PRODUCT ADVISORY LETTER

CBT primary bar mounting hole notification

March 17, 2022

CBT bar with <0.5" from hole center to end of bar

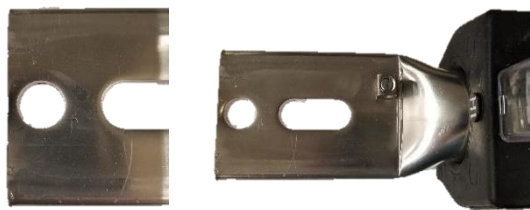
The current inventory of copper bars is slightly shorter than the required length, and while the inventory is consumed there may be as little as 0.430 inches from the center of the hole to the end of the primary bar. Historically these would have been rejected and new bars ordered, however with global supply challenges for copper, and to minimize delivery impacts on our customers, these bars will be used until they are consumed.

These units meet or exceed all routine tests per IEEE C57.13 and pass all other inspections. There are no other deviations from the dimensions specified in ANSI C12.11.
